DOWNTOWNER WEST SUBDIVISION,
RESUBDIVISION OF LOTS 6-10, UNIT ONE

APPLICATION NUMBER 24 DATE June 4, 2009

REQUEST Subdivision

DETAIL SITE PLAN

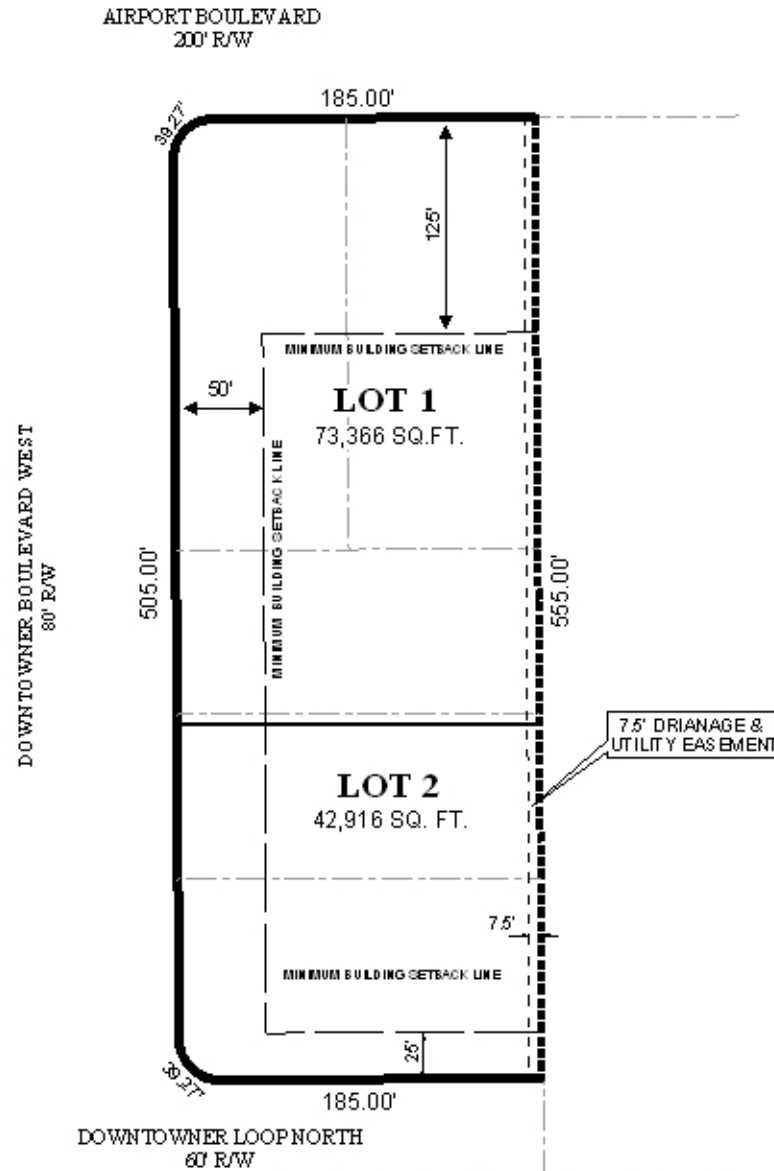
Engineering Comments: Must comply with all storm water and flood control ordinances. Any work performed in the right of way will require a right of way permit. Drainage from any newly constructed dumpster pads cannot discharge to storm sewer; must have connection to sanitary sewer.

Traffic Engineering Comments: Driveway number, size, location, and design to be approved by Traffic Engineering and conform to AASHTO standards.

With the site bounded by a major street and two minor street, access management is a concern; therefore, the placement of a note on the Final Plat stating that Lot 1 is limited to the existing curb cuts and that Lot 2 is allowed one curb cut to Downtowner Boulevard West and one curb cut to Downtowner Loop North, with the design, size and location to be approved by Traffic Engineering and conform to AASHTO standards.

- 1) the placement of a note on the Final Plat stating that Lot 1 is limited to the existing curb cuts, and that Lot 2 is limited to one curb cut to Downtowner Boulevard West and one curb cut to Downtowner Loop North, with the design, size and location to be approved by Traffic Engineering and conform to AASHTO standards.
